CCK-2767.0-1-25 Med Plaza Starbucks Renovation

ADDENDUM #2

UKHC MED PLAZA STARBUCKS RENOVATION

The Addendum will form a part of the Contract Documents and modifies the original Bidding Documents dated August 30, 2024.

ITEM NO. 2.01

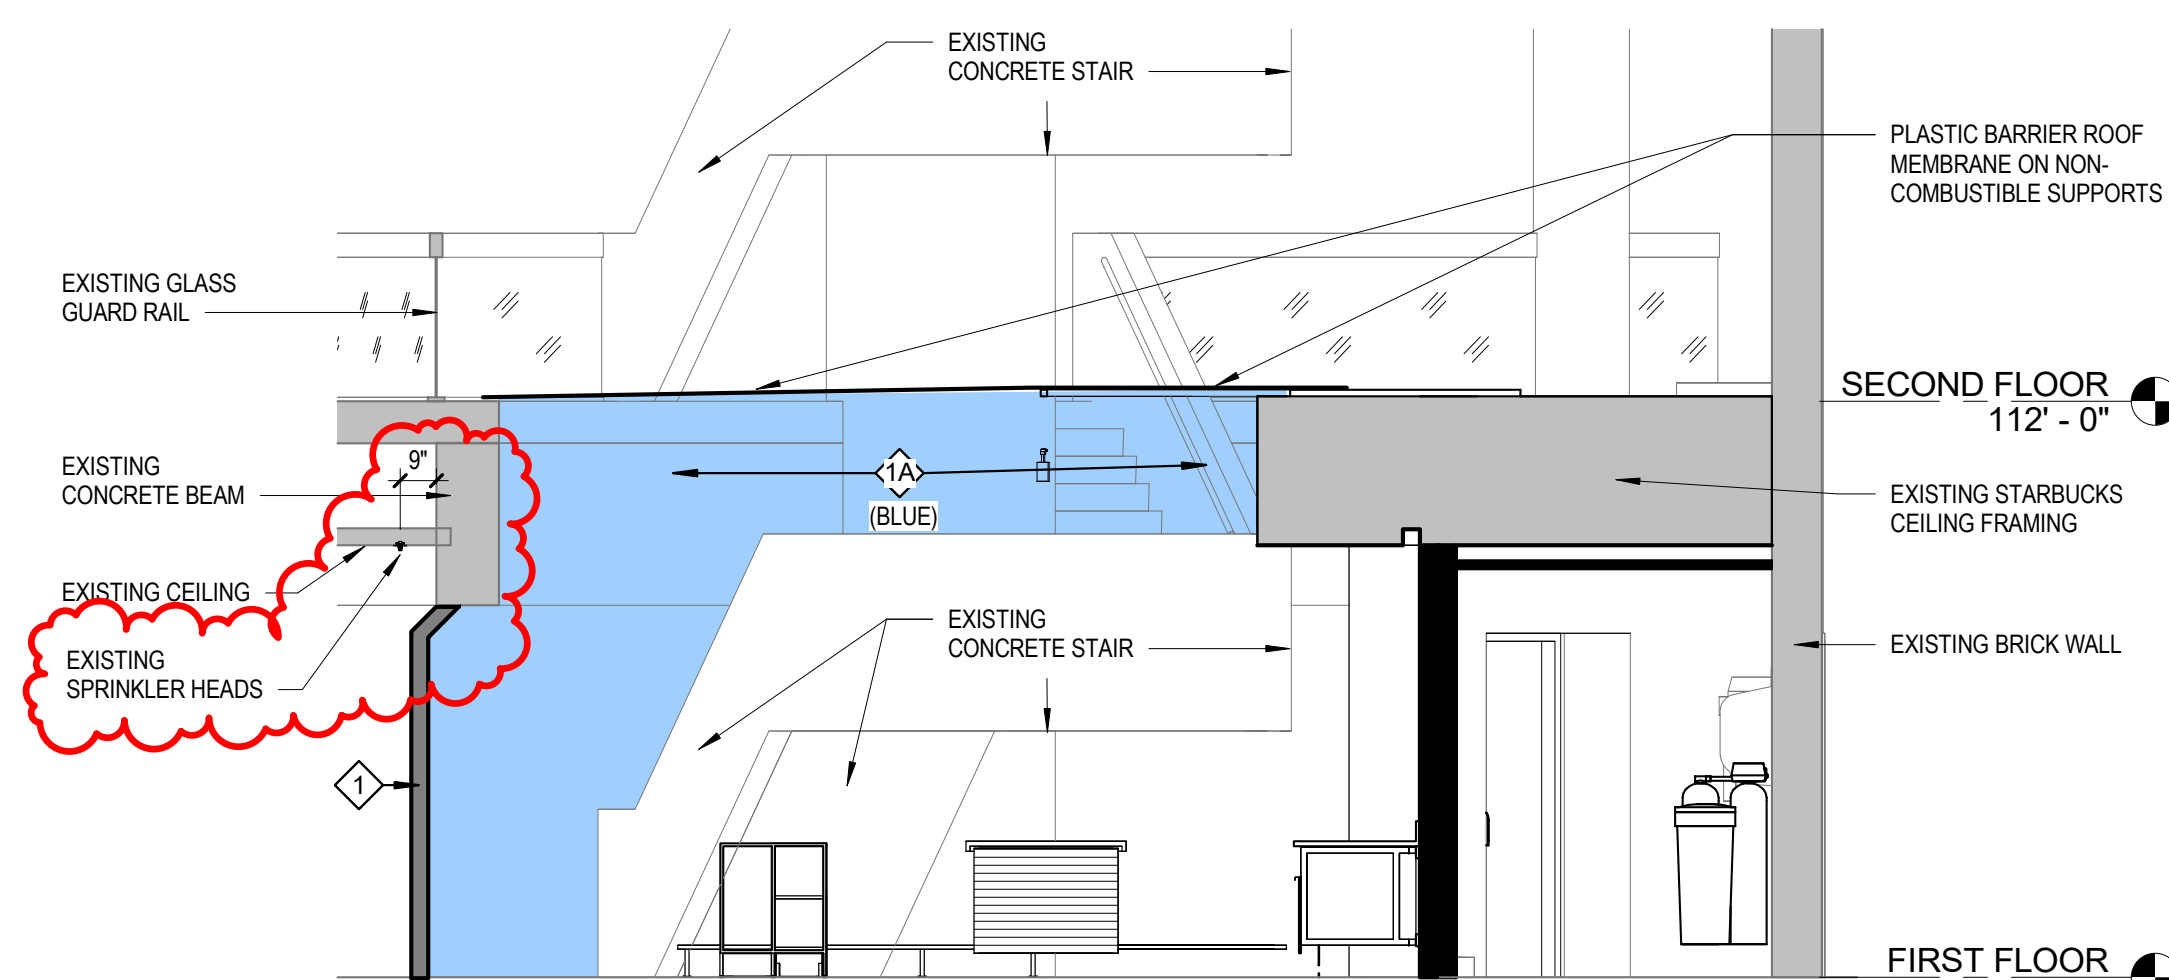
Refer to the attached revised Detail B/A-001 for revised barrier wall to avoid the sprinklers around atrium beam

A-001

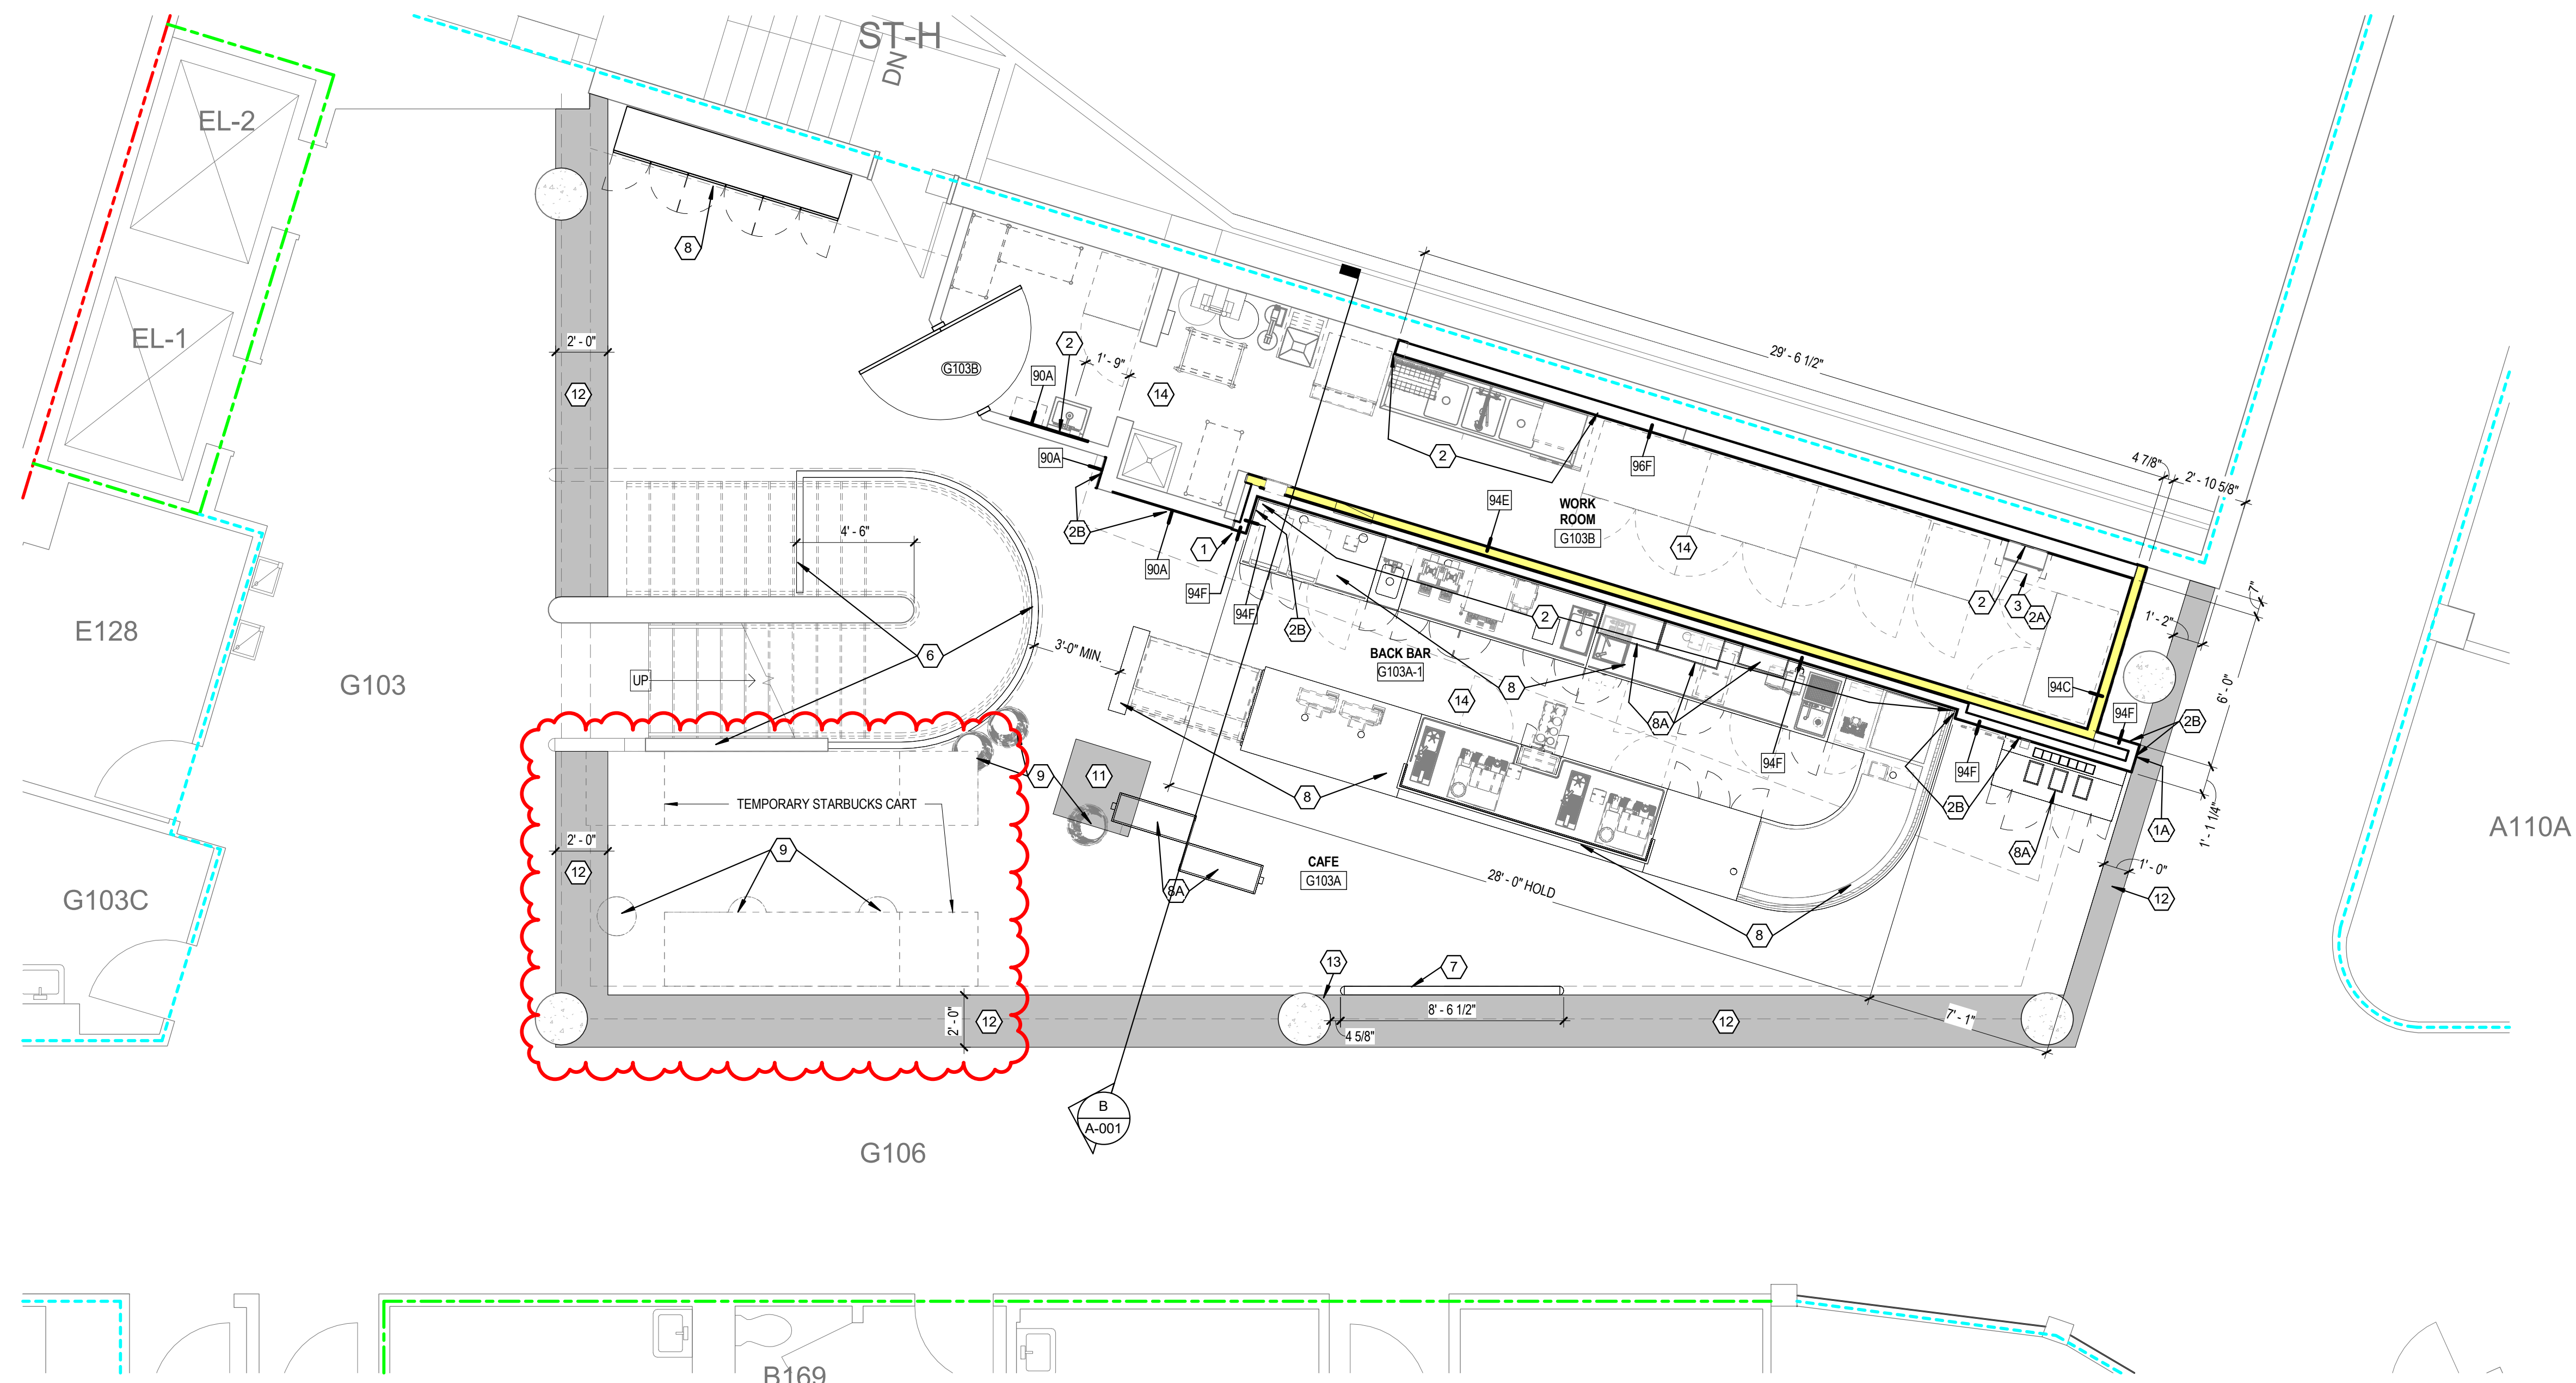
Refer to the attached revised Sheets A-001 and A-111. During construction Starbucks will operate a temporary service cart. The temporary barricade will need to be coordinated with its operational space requirements and connected services. The Owner will make all service connections. The contract work at the area outside the barricade will need to be performed after the barricade is removed and the cart relocated/removed.
